Riverside Energy Park

Statement of Common Ground: Environment Agency

8.01.03

May 2019 | Revision 0 (Deadline 2)

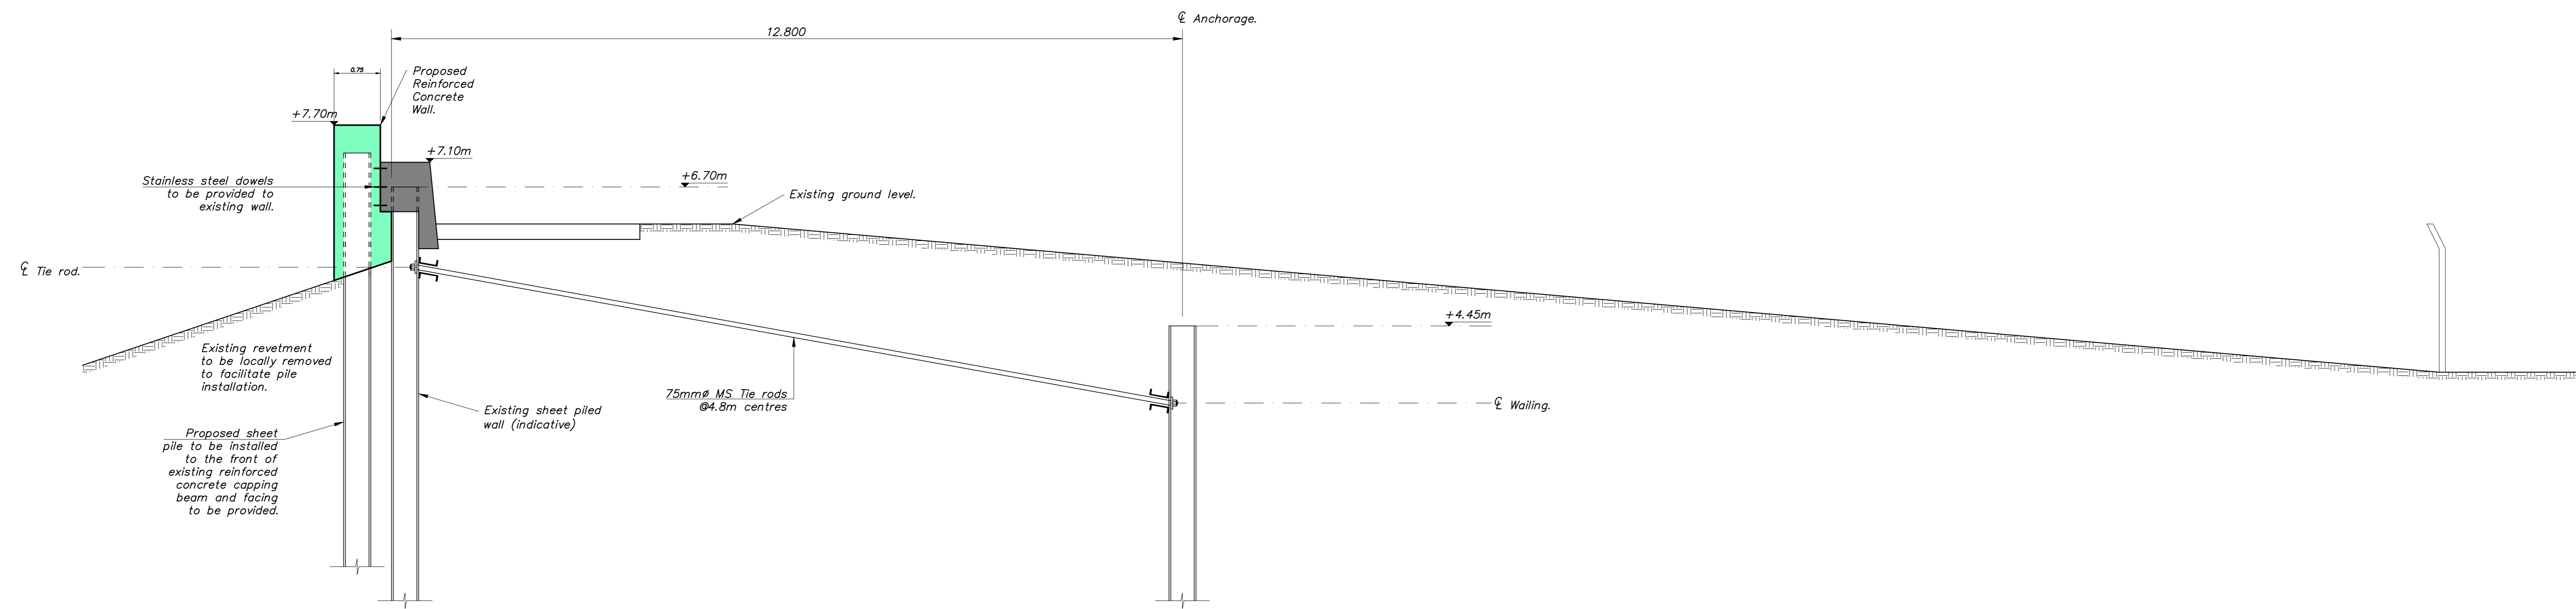
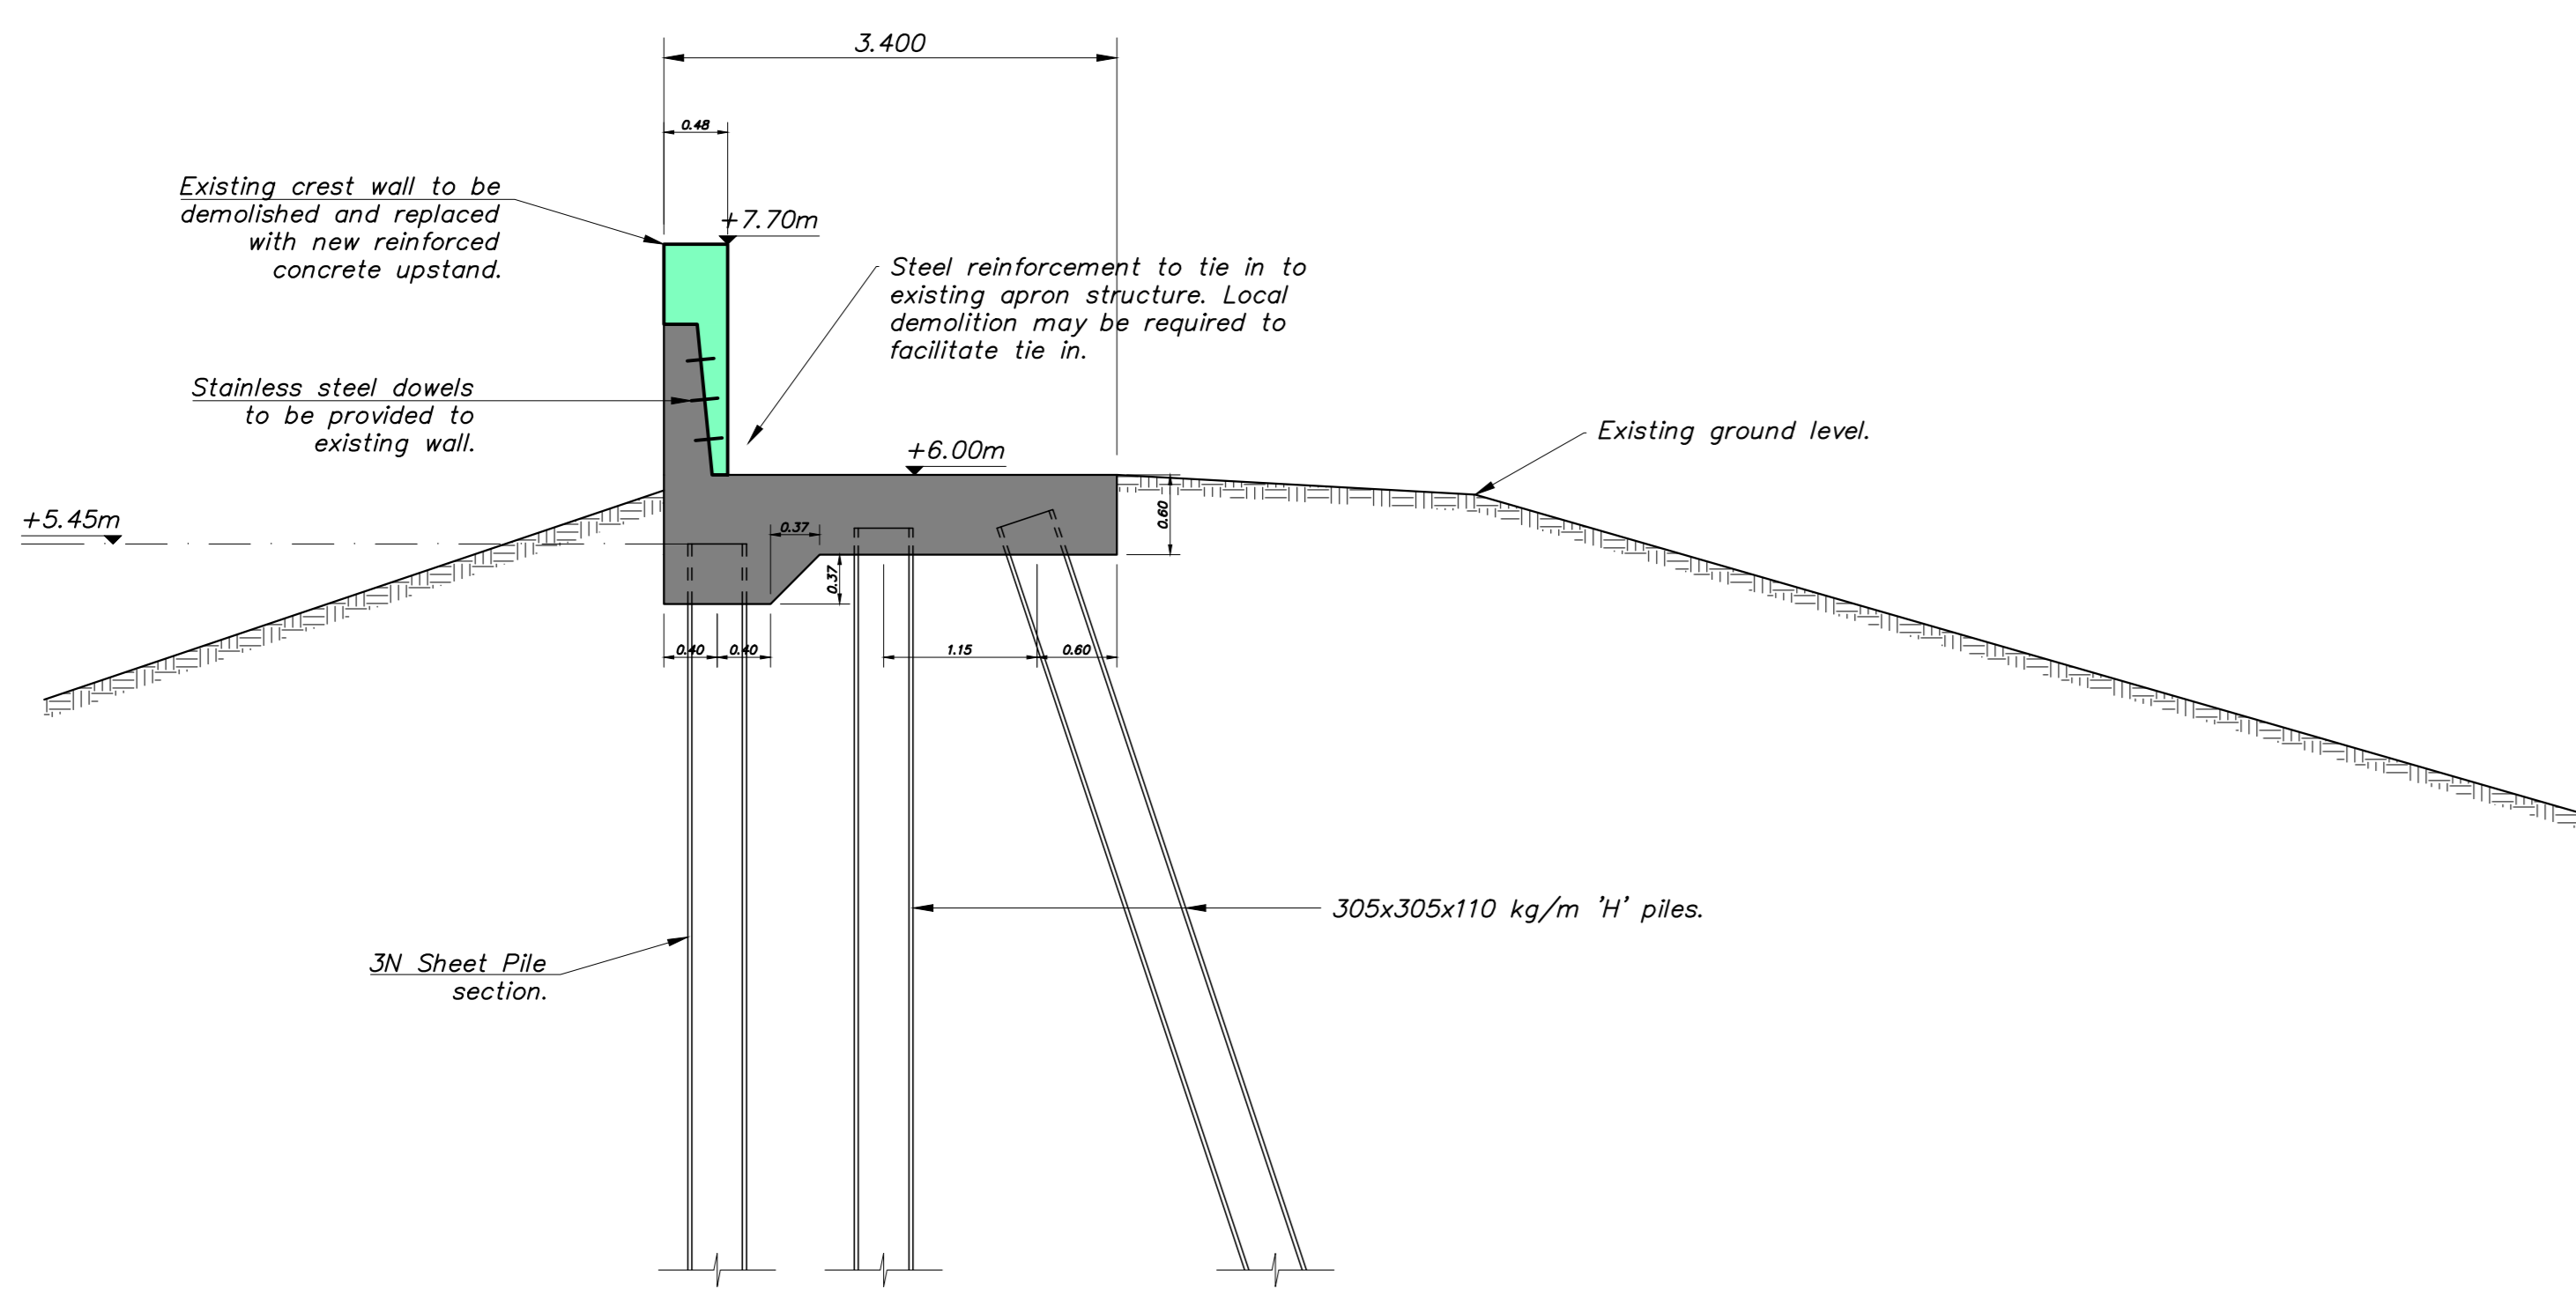
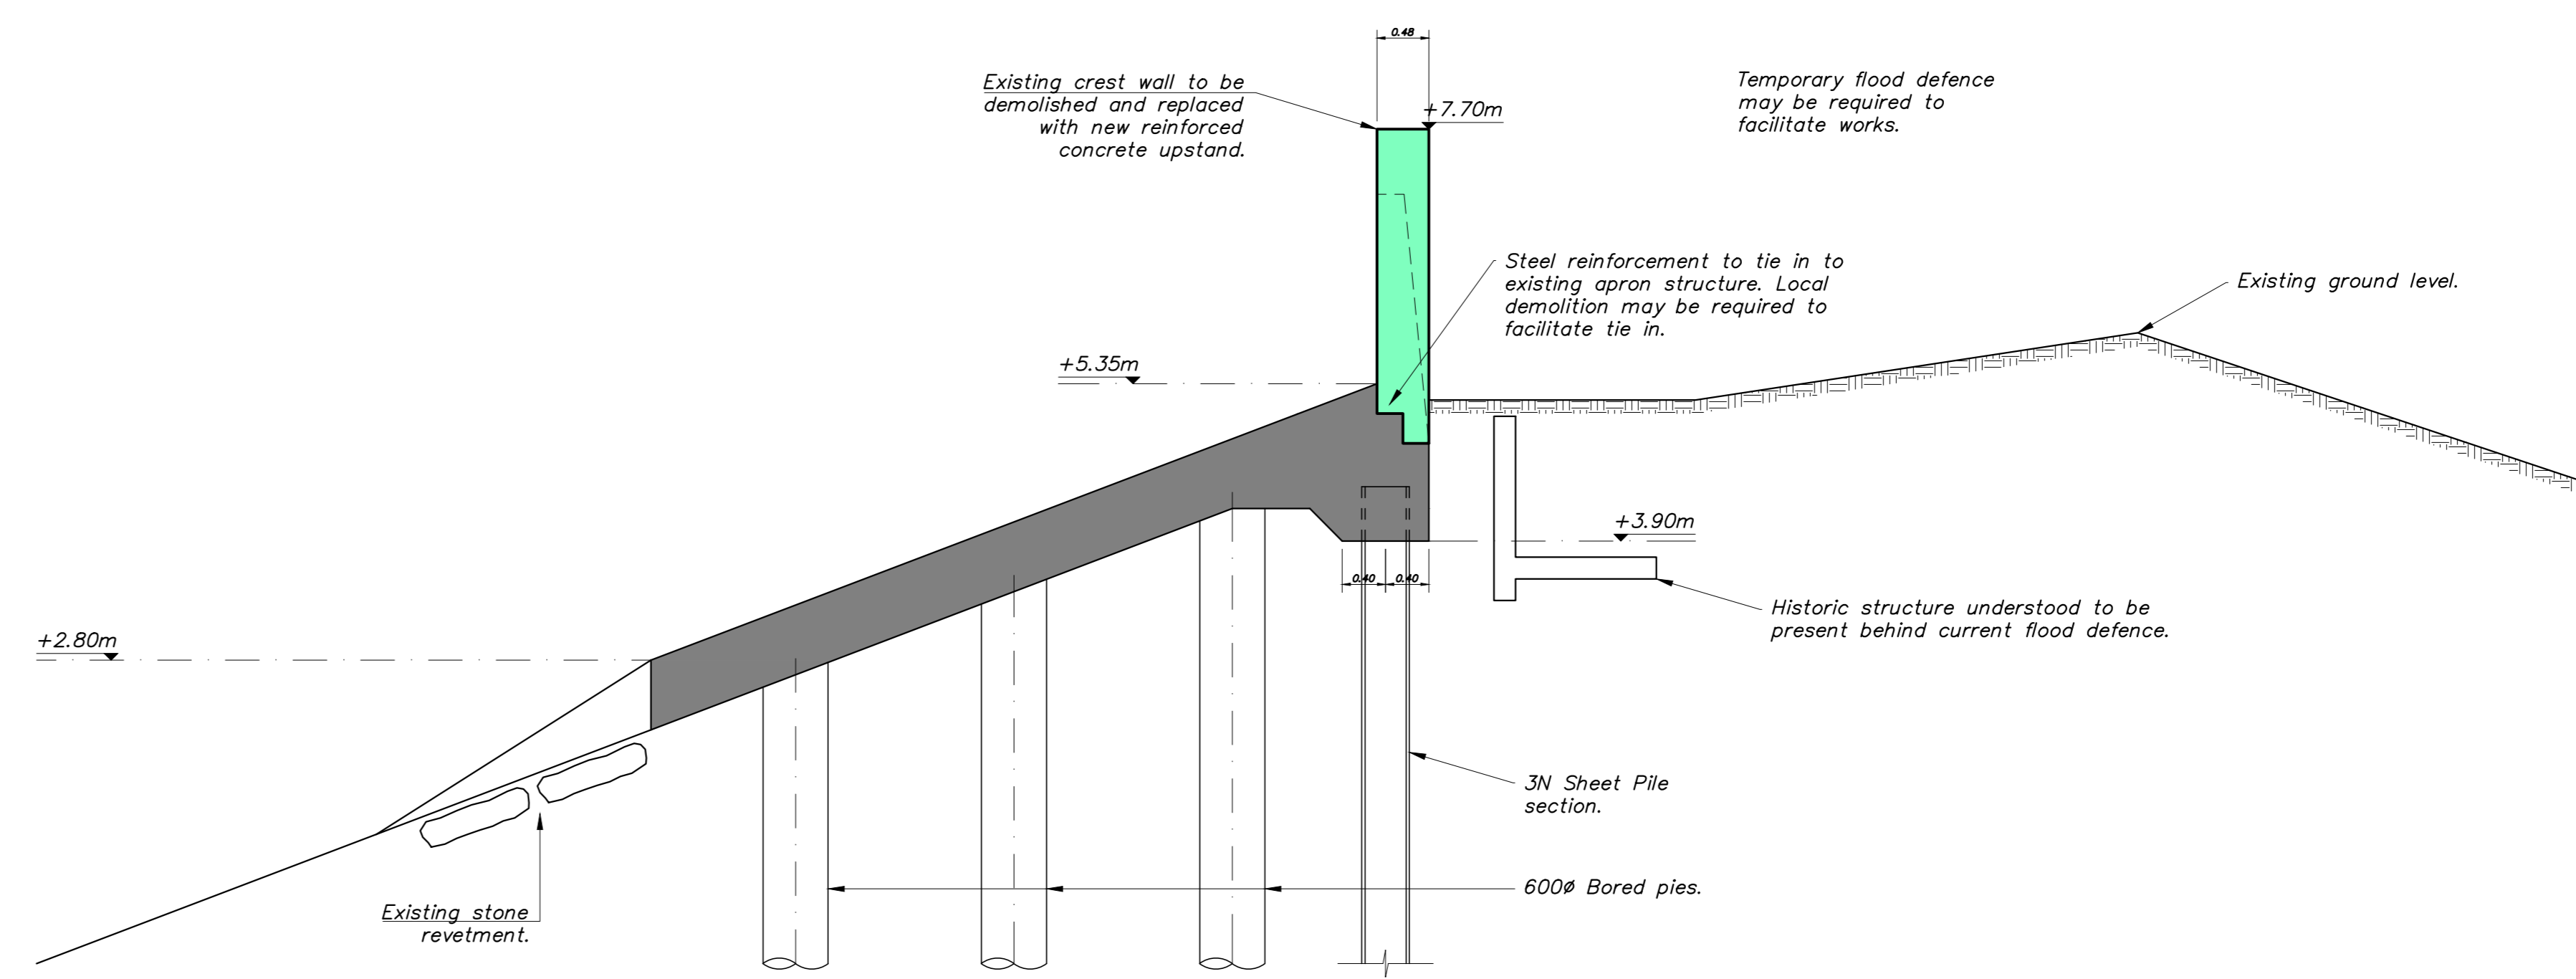
2.2.1 Through the indicative diagrams C110-113 (appended to this SOCG), the Parties agree that it has been demonstrated that the Proposed Development does not preclude the raising of the flood defence to the second stage level (of 7.7m AOD expected in 2070) proposed in the Thames Estuary 2100 Plan, and does not significantly restrict future defence raising options. These illustrative drawings were provided at the request of the EA in order to provide examples of technical solutions that could be adopted in the future should the need ever arise to raise the flood bank in line with the requirements of the Thames Estuary 2100 Plan.

Date	13.05.19
A1 Scale	1:750
Drawn by	AG
Checked by	PC
Drawing Number	VAA-WA-50080100_1.0

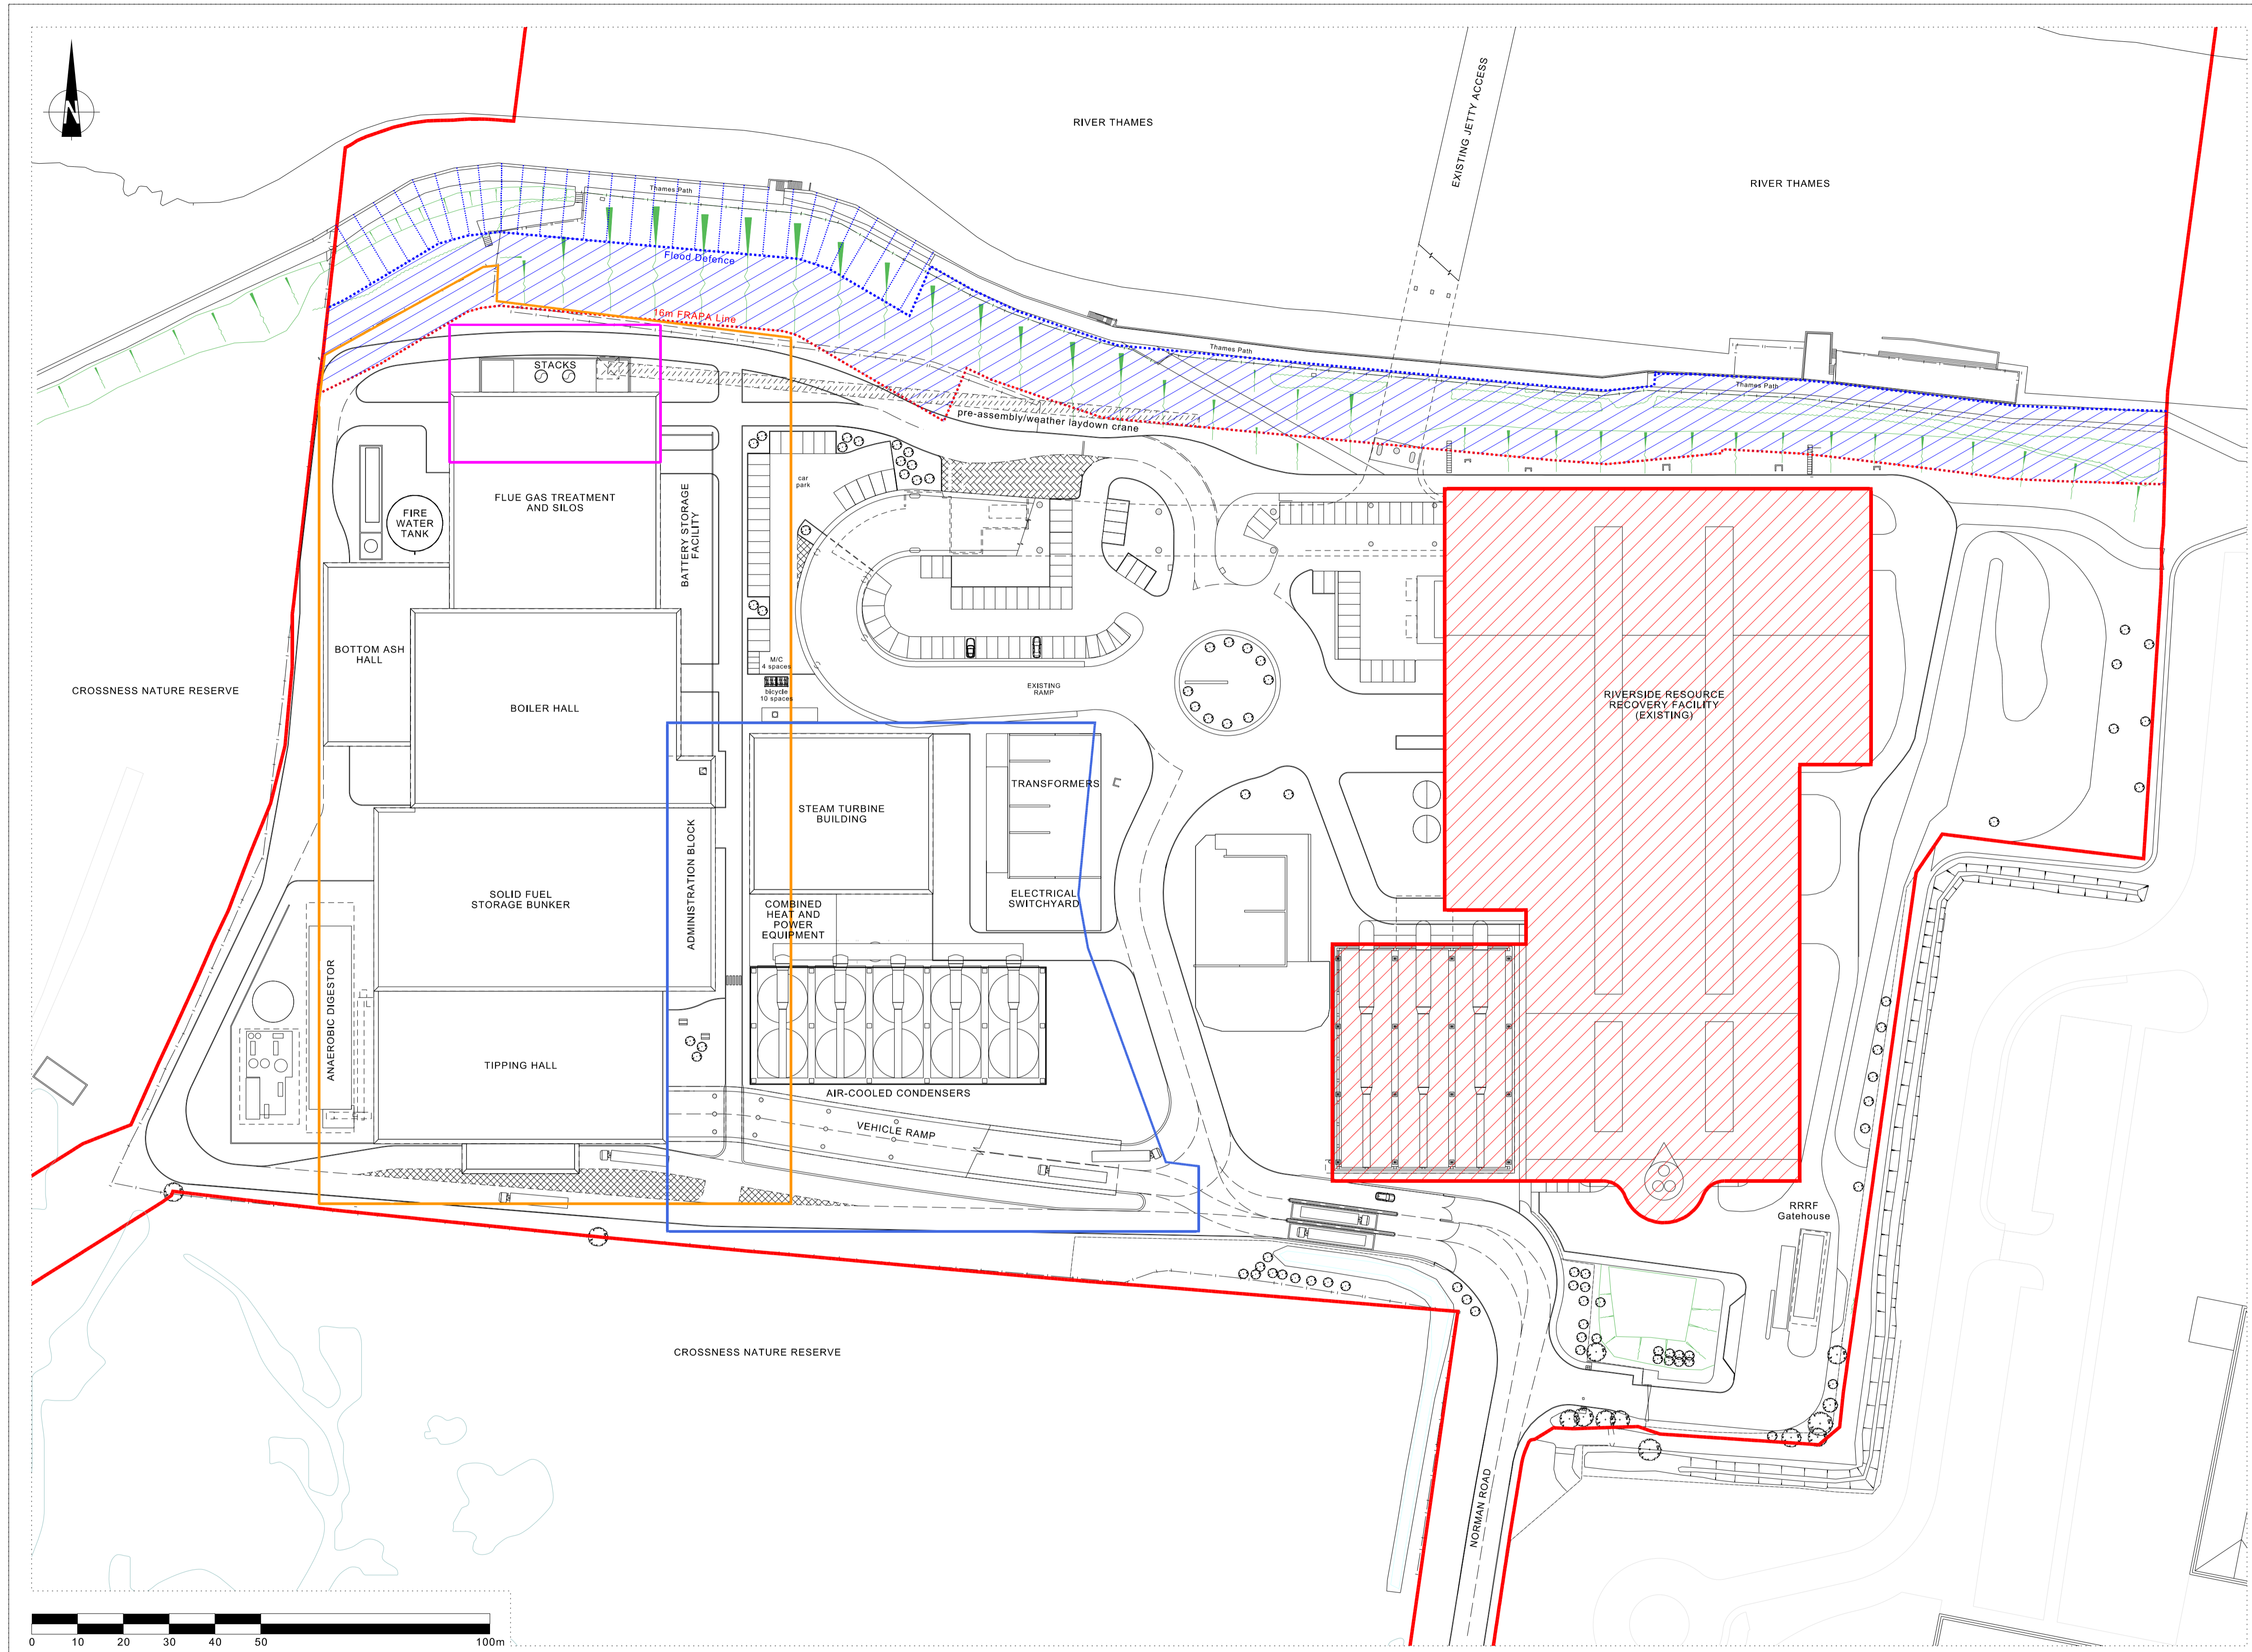
2.3.1 The Flood Risk Activity Permit Area (FRAPA) for REP is shown in diagram VAA-WA-50080100_1.0, VAA-WA-50080110_1.0 and VAA-WA-50080101_1.0 appended to this SOCG.
